IOWA DOT	REVISION	
	2	10-17-23
STANDARD ROAD PLAN		DR-306
		SHEET 1 of 2

**PRECAST CONCRETE HEADWALL
FOR SUBDRAIN OUTLETS**

LONGITUDINAL AND TRANSVERSE OUTLETS

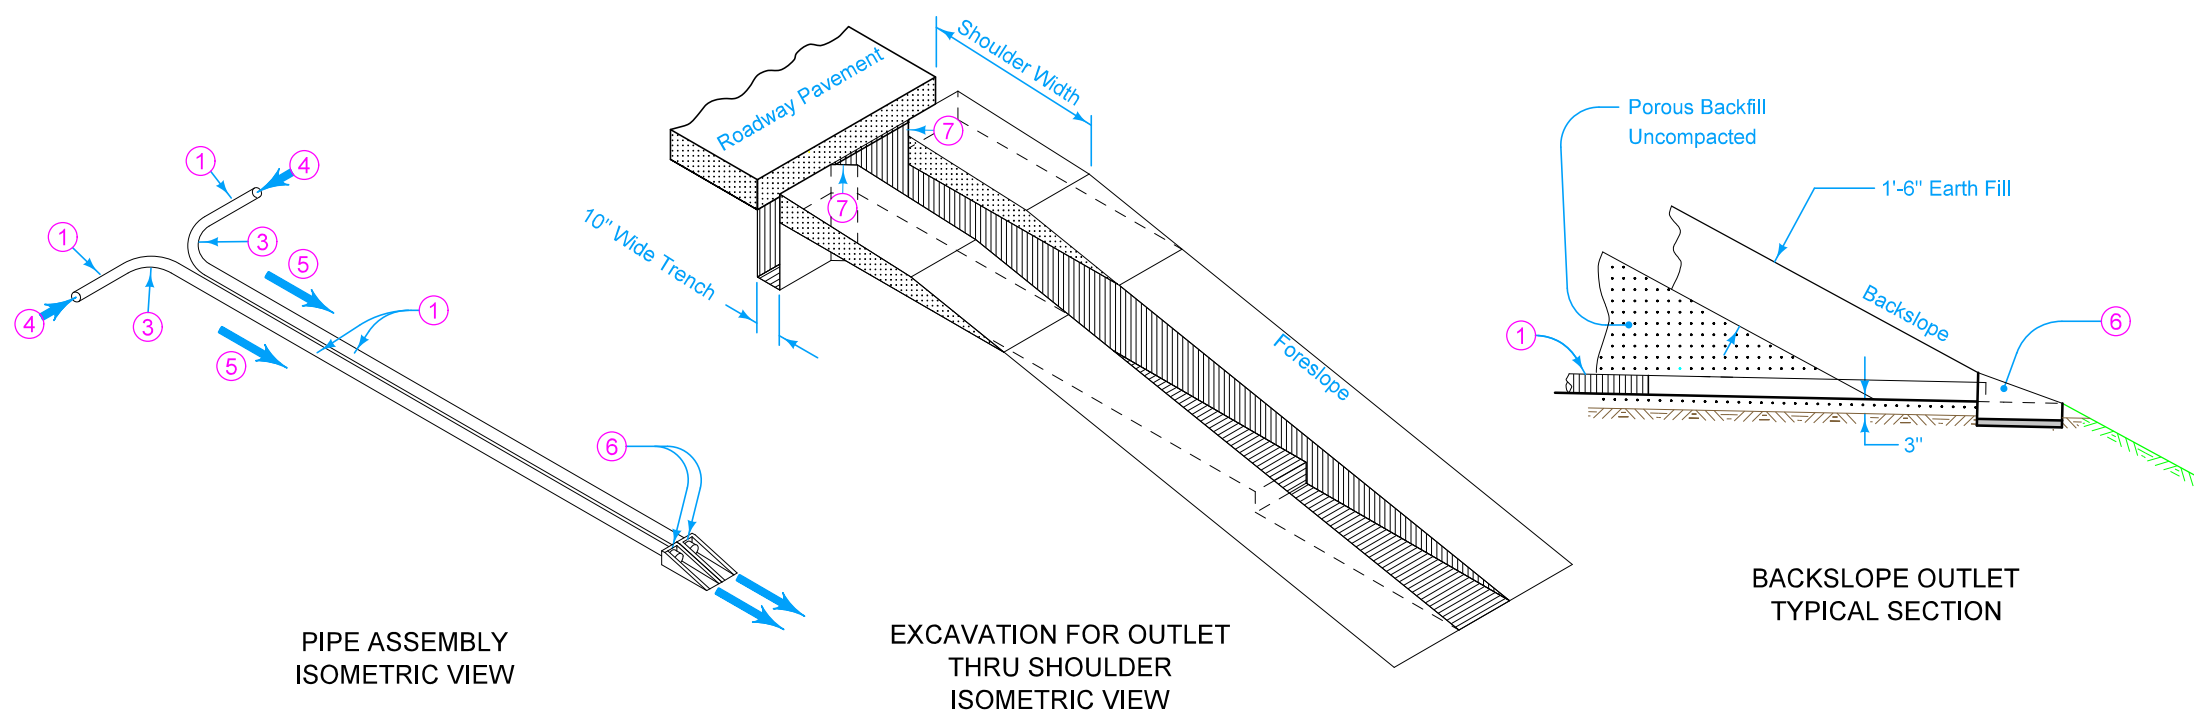
REVISIONS: Change from granular cap to top soil cap.

- ① Perforated Subdrain (Polyethylene Corrugated Tubing).
- ② On projects where existing shoulder material is removed, replace the shoulder material according to Article 2502.03, C of the Standard Specifications.
- ③ 'Y' or 'T' connection will not be allowed. Place subdrain on 1 foot minimum radius.
- ④ Direction of flow.
- ⑤ 6 inch minimum drop in elevation between longitudinal subdrain and outlet. 12 inch minimum drop for projects using recycled PCC subbase.
- ⑥ Precast concrete headwall.
- ⑦ Bevel the trench to provide a minimum of 3 inches of porous backfill surrounding all portions of subdrain pipe.
- ⑧ Place Top Soil over outlet and carefully compact to avoid damaging outlet pipe.
